ECE/TRANS/WP.29/GRSG/2007/13  
1 February 2007

Regulation No. 58 (Rear underrun protection)

Proposal for draft amendments to Regulation No. 58

Submitted by the expert from Japan

Figure 1

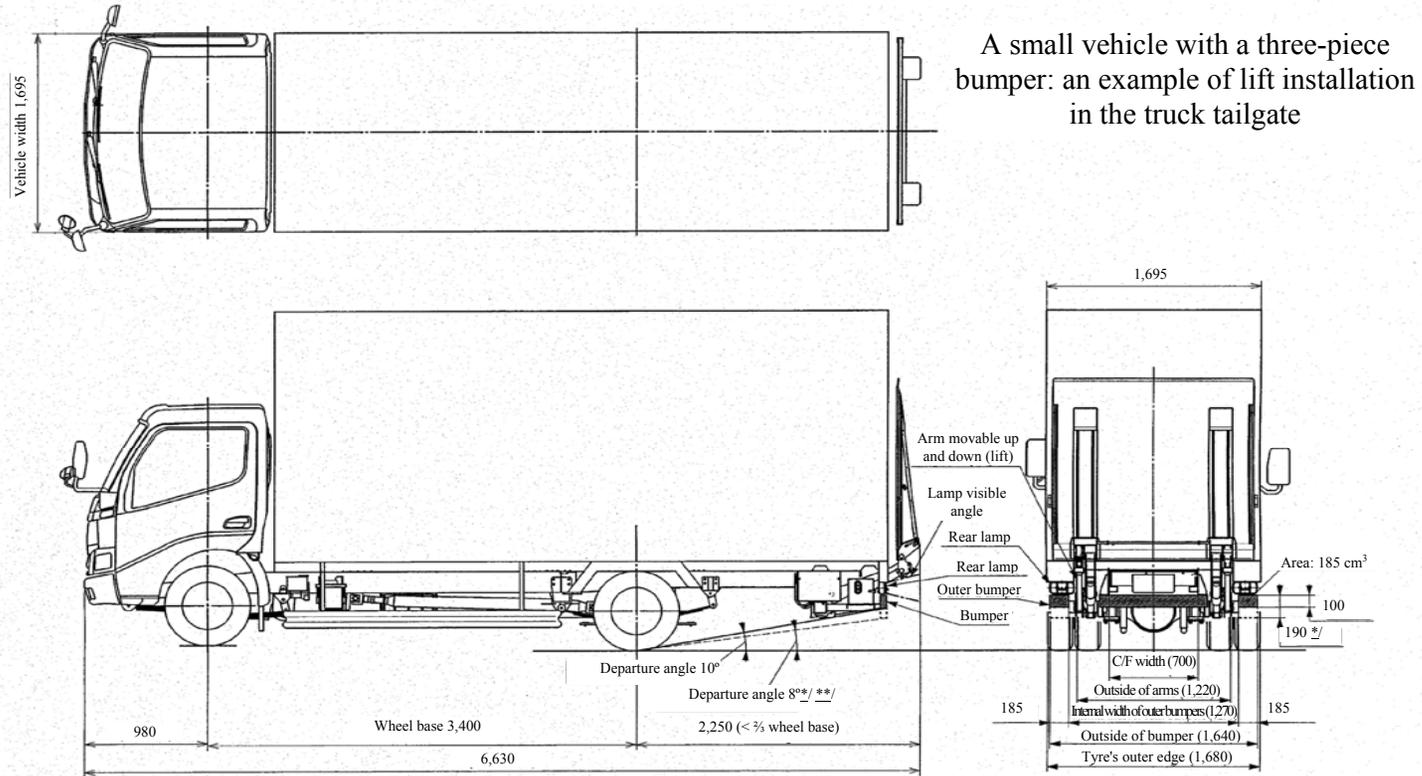
1. Bumper width direction (see Figure 1)

The outer bumpers need to be positioned in such a way that they do not interfere with the lift's arms installed at the outside of the chassis frame. If the outer bumpers are positioned in such a way that they do not protrude outside the tyre's outer edge, it will be impossible to secure sufficient length and area of bumpers for general vehicles with GVW of seven tonnes or less.

2. Bumper height direction (see Figure 1)

If the bumper height is increased in an upward direction to secure a wider area, it will interfere with the rear lamps and body structures. If the bumper height is increased in downward direction, the departure angle will decrease, which results in poor drivability.

\*/ Indicates inconformity resulting from securing the bumper area of 350 cm<sup>2</sup> or more.

\*\*/ If the bumper area of 350 cm<sup>2</sup> or more is secured and the truck is loaded at rated capacity, the departure angle will be 7°.

**However, in cases where it is difficult to secure this effective surface area of the underrun protection in a truck with a gross vehicle weight (GVW) of seven tonnes or less due to its structure, Contracting Parties may specify in their national regulations the size of such area."**

**However, in cases where it is difficult to secure this effective surface area of the underrun protection in a truck with a gross vehicle weight (GVW) of seven tonnes or less due to its structure, Contracting Parties may specify in their national regulations the size of such area."**
